**Building #046 Renovations
For
College of Social and Applied Human Sciences
Project No. 504034**

ADDENDUM 6

December 12, 2018

**REVISED MILLWORK PLAN
MW-107**

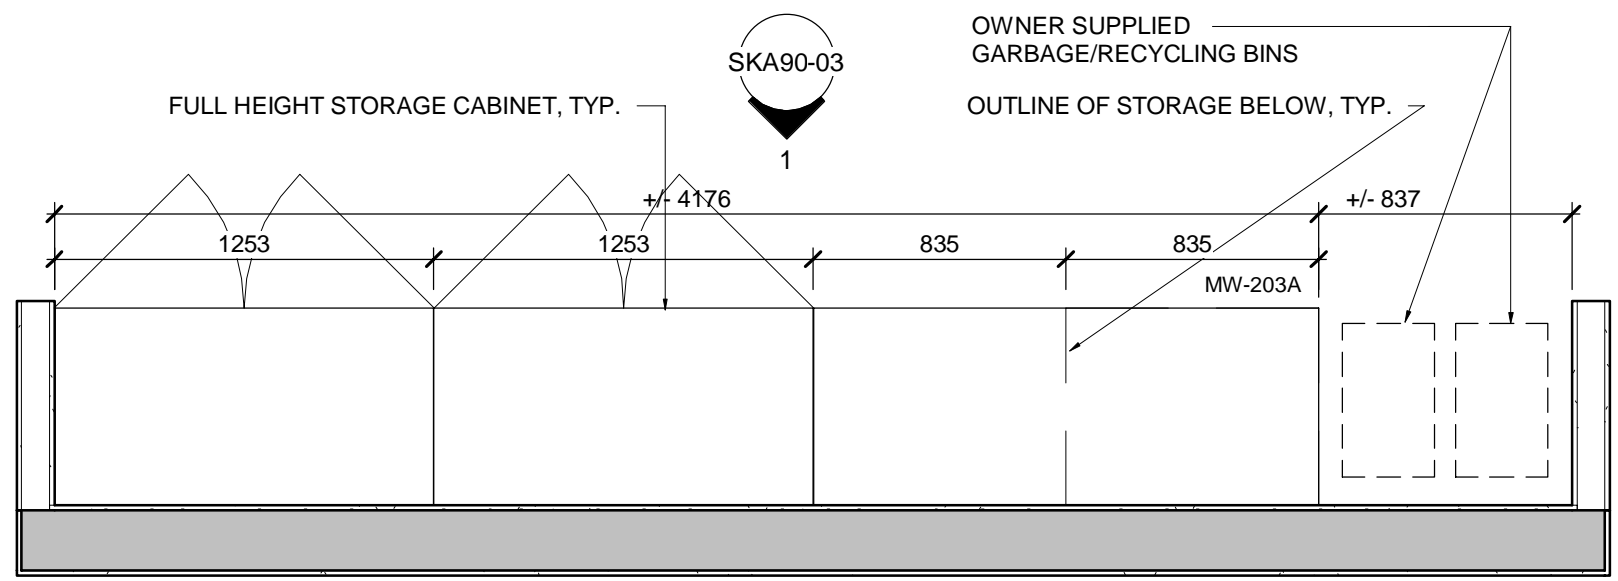
.1 **REVISE:** Millwork MW – 107 details 1 and 2 on architectural drawing A90 as per attached architectural sketches SKA90-01, SKA90-02 and SKA90-03 dated December 10, 2018:

MILLWORK ELEVATION
MW-203A

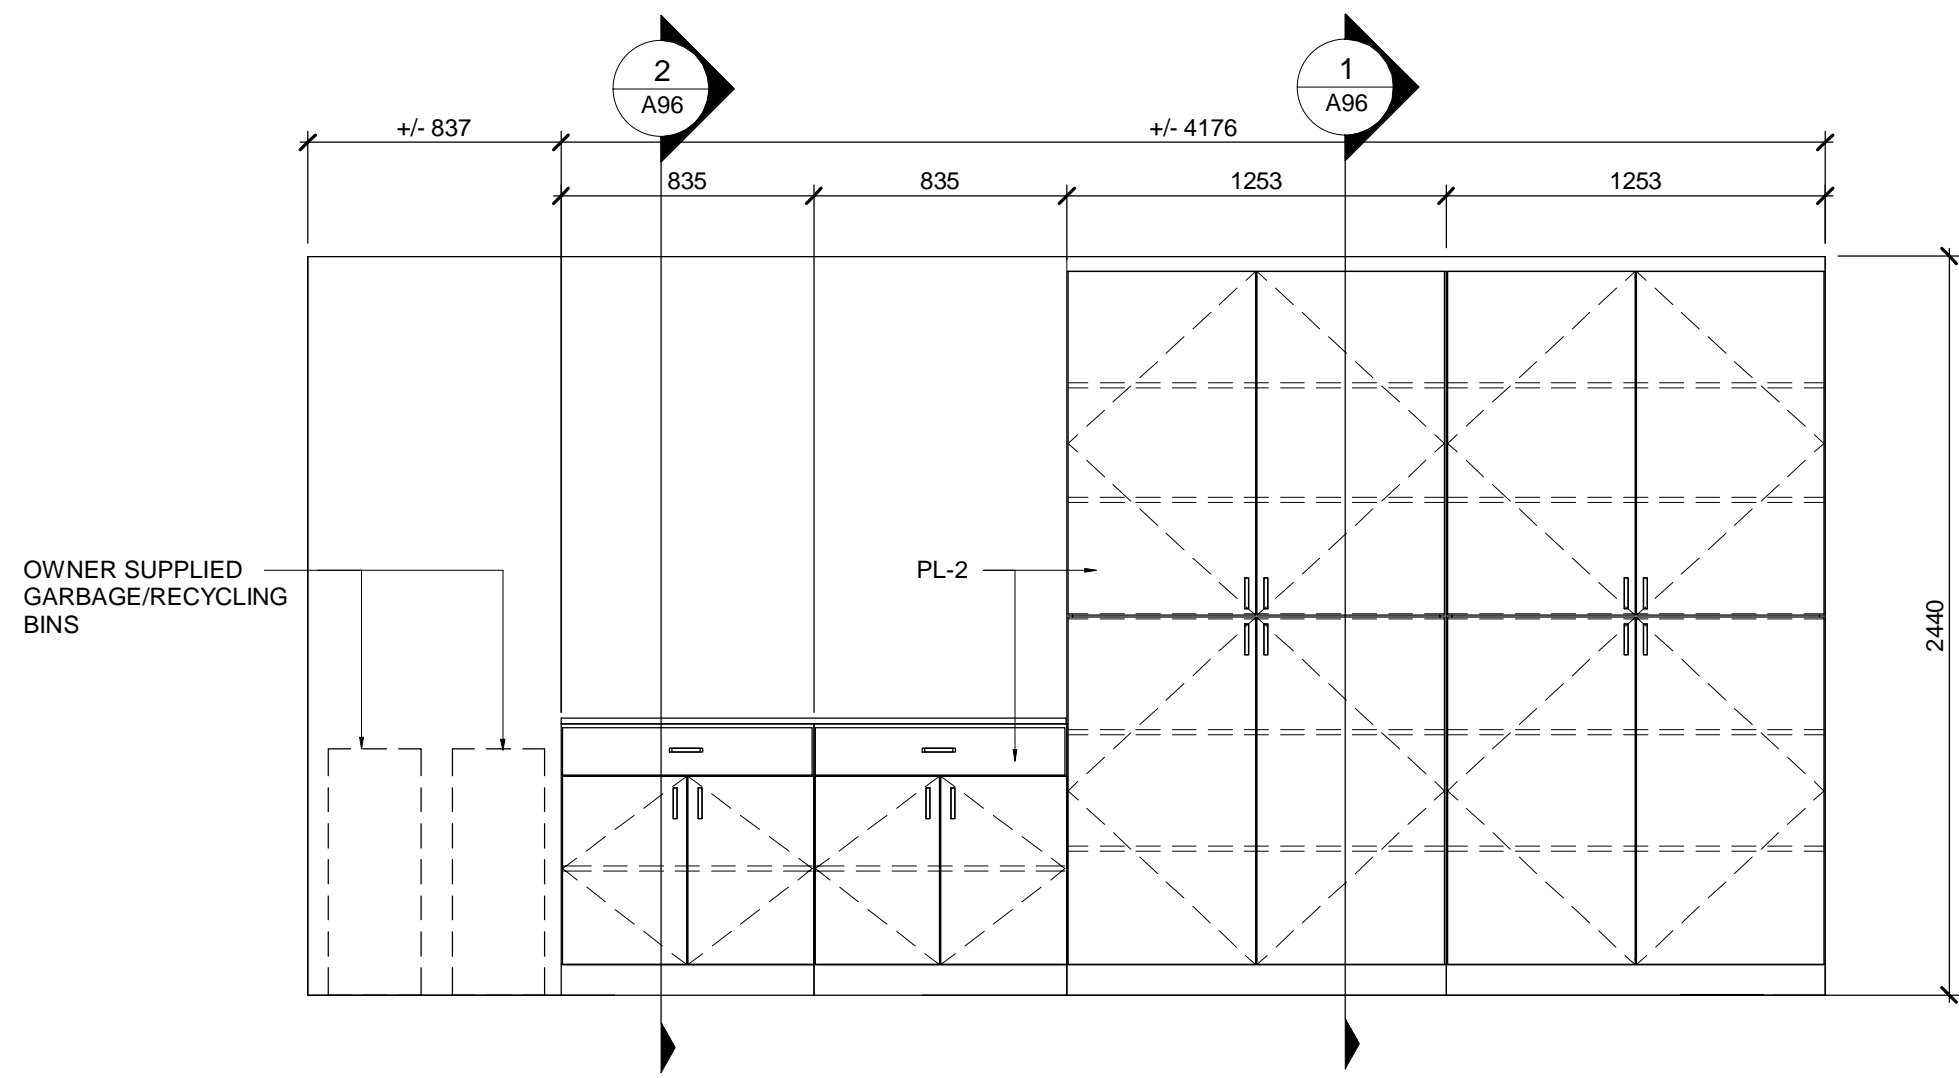
.2 **REVISE:** Millwork MW – 203A details 5 and 6 on architectural drawing A90 as per attached architectural sketches SKA90-01, SKA90-02 and SKA90-03 dated December 10, 2018
